To:	Jemma Foster	From:	Drainage (Cecily Austin)
------------	--------------	--------------	--------------------------

Planning App Ref:	PL/2026/04290
Service Ref:	Drainage
Date:	25/08/2026

Discharge of Conditions 8 (Parameter Levels Plan), 9 (Surface Water), 26 (Travel Plan), 32 (Hard and Soft Landscaping) & 35 (External Lighting) of planning application 19/11459/OUT

Elm Grove Farm, Drynham Road, Trowbridge, BA14 0PL

Figure 1: Southern portion of Wetland Basin 2 showing the proposed ditch culvert encroaching into the basin footprint. The basin inlet is located centrally.

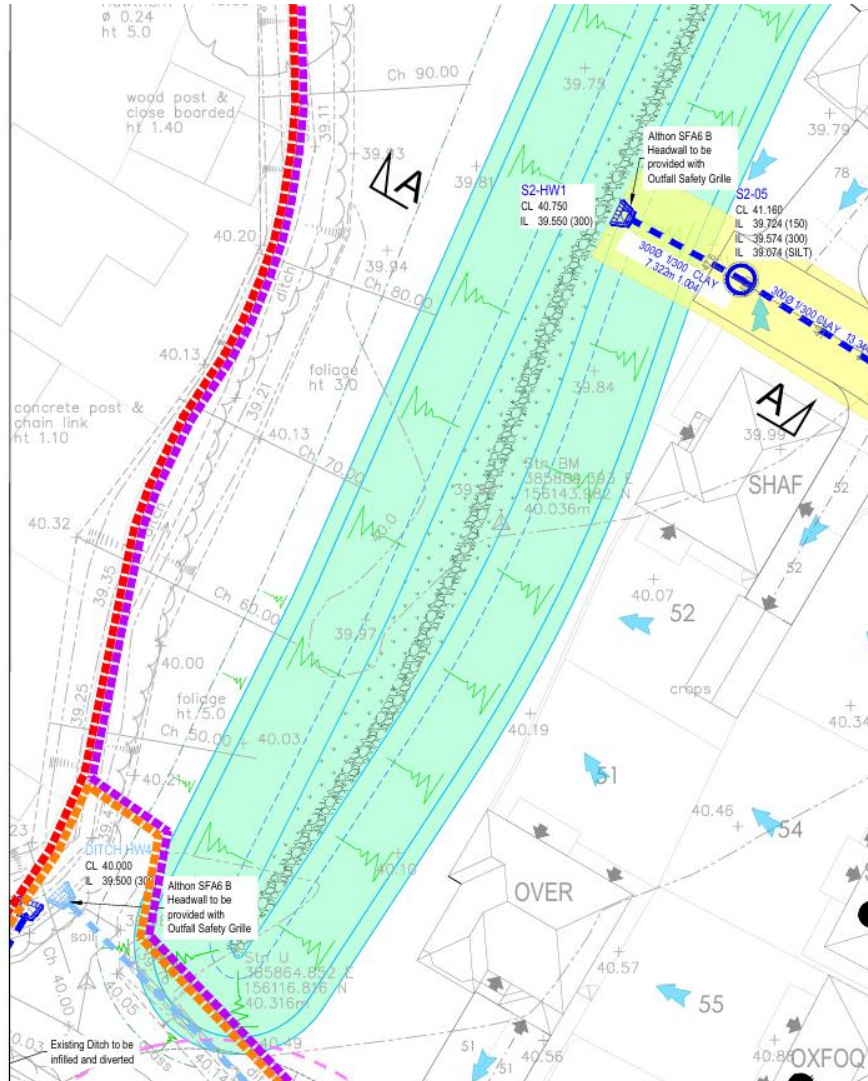
A culverted ditch is also proposed along the southern edge of the basin. Further cross-sections and construction details are required to demonstrate that the proposed culvert arrangement is suitable. Based on the submitted drawings, the culvert appears to encroach into the basin footprint, and it is unclear how this arrangement would function in practice (see Figure 1 below). As submitted, insufficient information has been provided to demonstrate that the culvert would not compromise the storage capacity, operation, or maintenance of the basin. Clarification is therefore required.

It is also unclear how the southern portion of the basin contributes to storage. It is understood that flows will enter the basin centrally whilst the outfall is located to the north. Depending on the basin grading, the southern area may either be isolated from incoming flows or may not hydraulically connect to the basin outlet. Additional level information and hydraulic evidence should be provided to demonstrate that the basin functions effectively.

- Cross-sections and construction details for the proposed ditch culverts, as noted in section 4.2
- Clarification of the final design and operation of Wetland Basin 2, including evidence that the full basin volume contributes to attenuation, as noted in section 6.2
